SUBSURFACE WASTEWATER DISPOSAL SYSTEM APPLICATION

Town Or Plantation	Augusta
Street Subdivision Lot #	Eight Rod Road

AUGUSTA PERMIT # 1,407 TOWN COPY

Town, City, Plantation: Augusta
Street, Road, Subdivision: 8 Rod Road
Owners Name: Paul DuFour

Section A Page 4

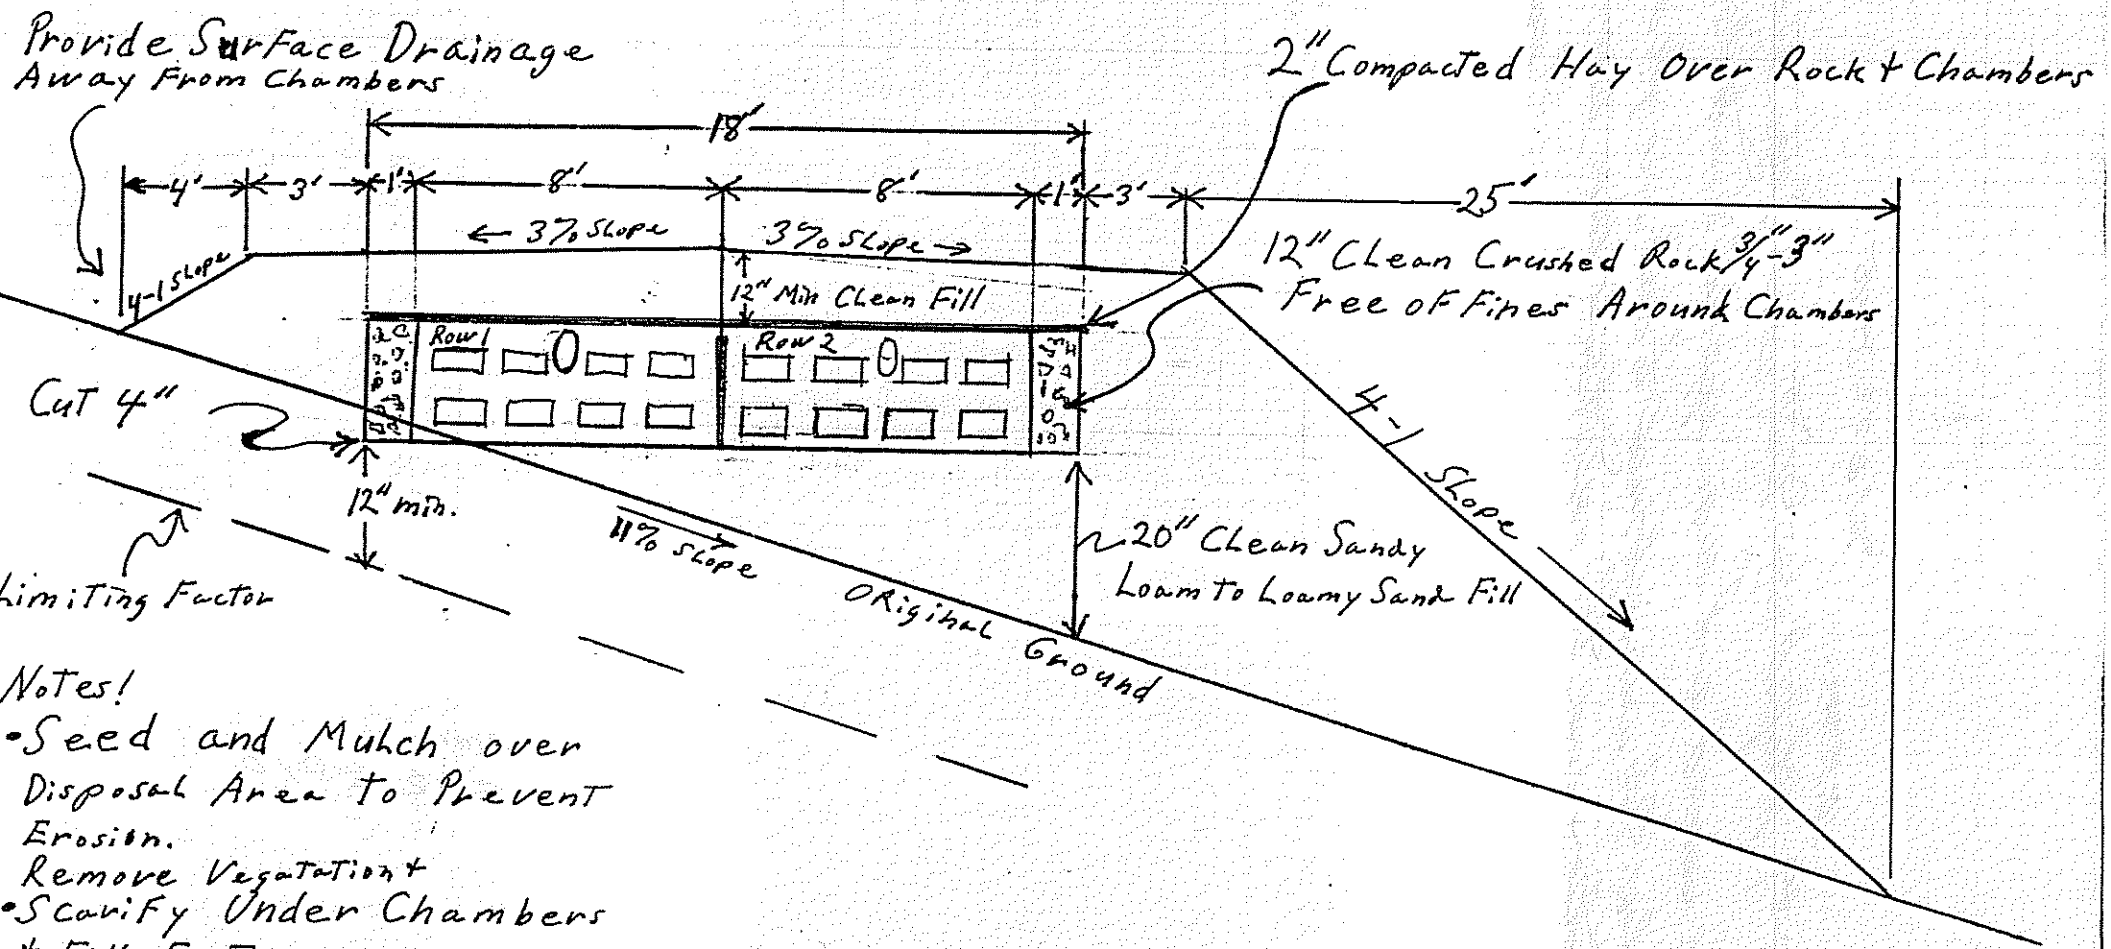
8-28-89 notified own that wood below chambers had to be removed and screen applied to outside edge of chambers. He was informed to call me for another inspection once the corrections have been made.
